IN RE: REVIEW OF LUMA'S  
SYSTEM OPERATION PRINCIPLES

**CASE NO. NEPR-MI-2021-0001**

**SUBJECT: Submission of Additional Information  
Requested in Technical Conference, Supplemental  
Responses to Questions and Clarifications.**

**MOTION IN COMPLIANCE WITH ORDER SUBMITTING ADDITIONAL  
INFORMATION AND SUPPLEMENTAL RESPONSES TO QUESTIONS POSED IN  
TECHNICAL CONFERENCE AND SUBMITTING CLARIFICATIONS**

**Figure 3-1. General Process to Retire a Unit**

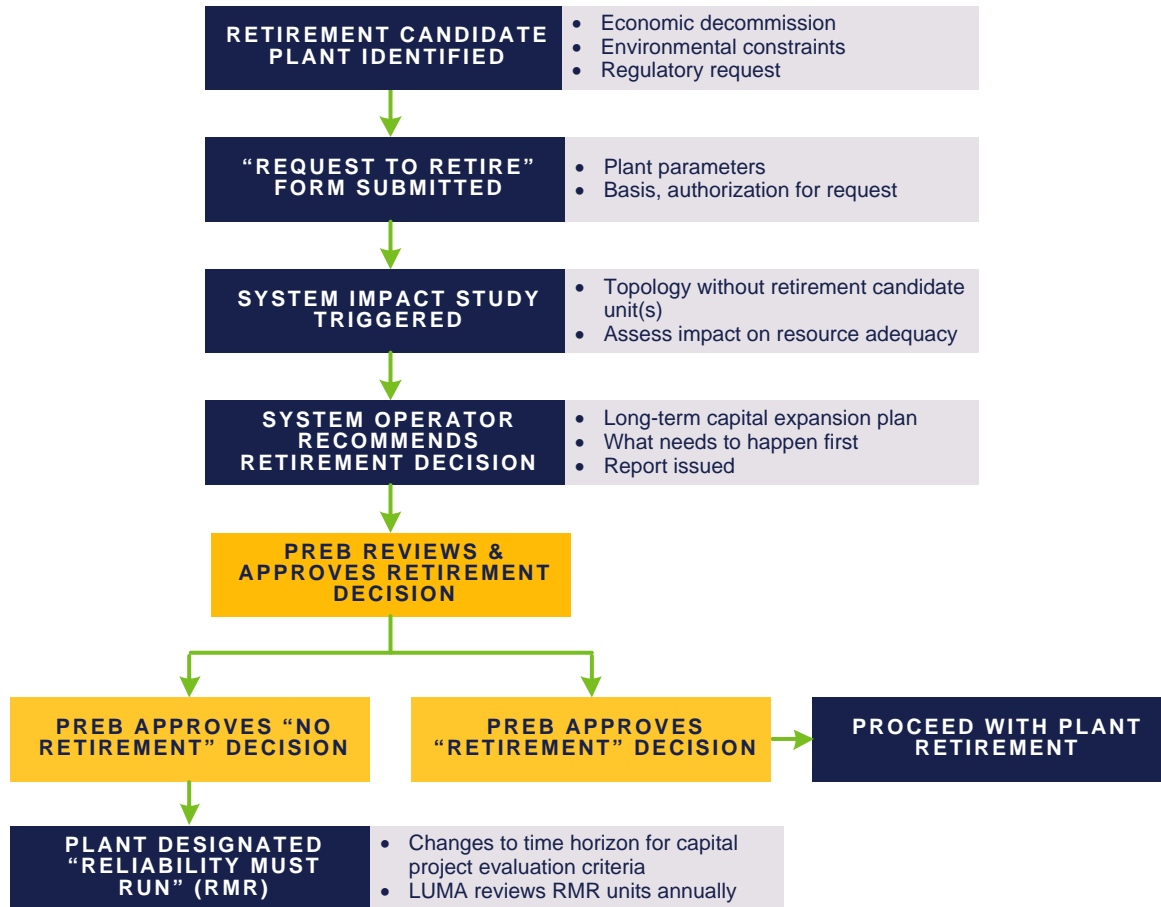
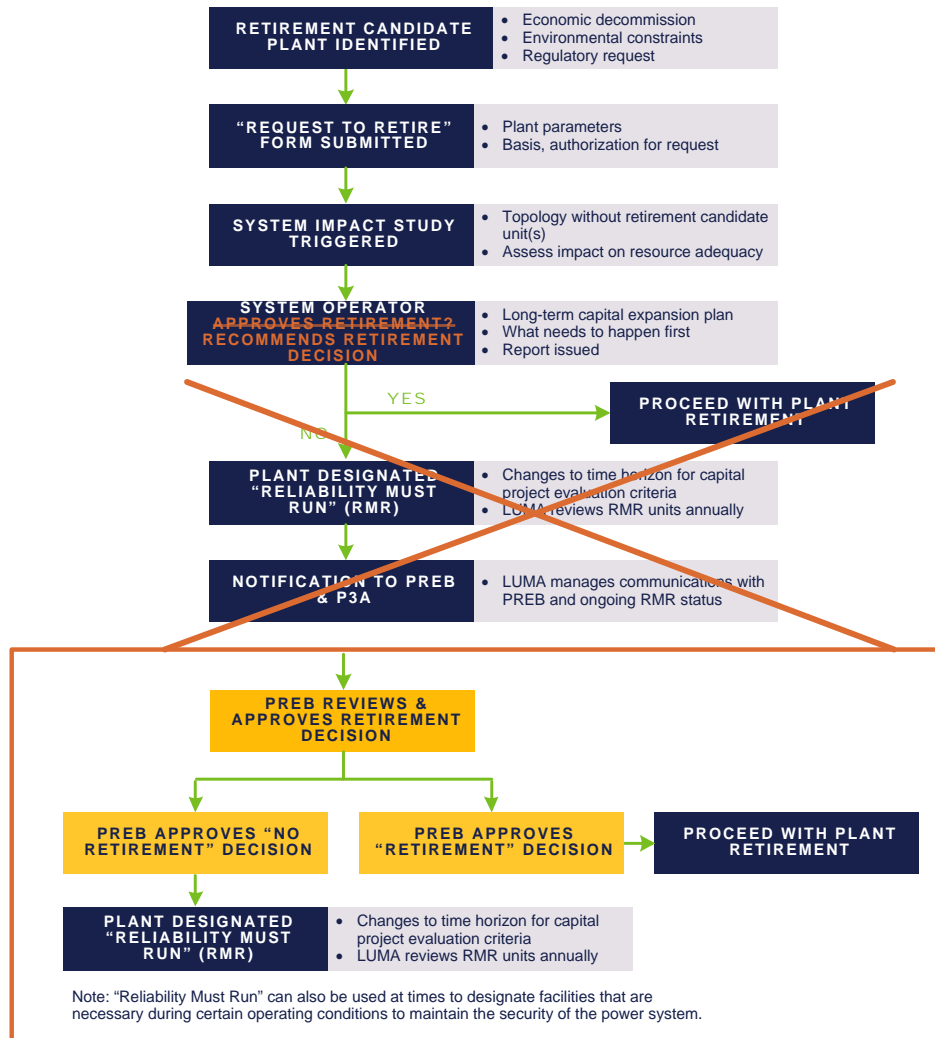
LUMA seeks to clarify the process for the retirement of generation assets described in the System Operating Principles filing of February 23, 2021, Section 3.3, System Operator Will Coordinate All Generation Retirement Requests.

To clarify the process for the retirement of generation assets, LUMA has provided an update to Section 3.3 of the LUMA System Operating Principles filing.

Please refer to TC-RFI-LUMA-MI-21-0001-210510-PREB-001 Attachment 1 for a clean version of the updated Section 3.3. Please refer to TC-RFI-LUMA-MI-21-0001-210510-PREB-001 Attachment 2 for a blackline version of Section 3.3. outlining the changes made as part of this response.

Figure 3-1 below describes the general process to retire a generating unit.
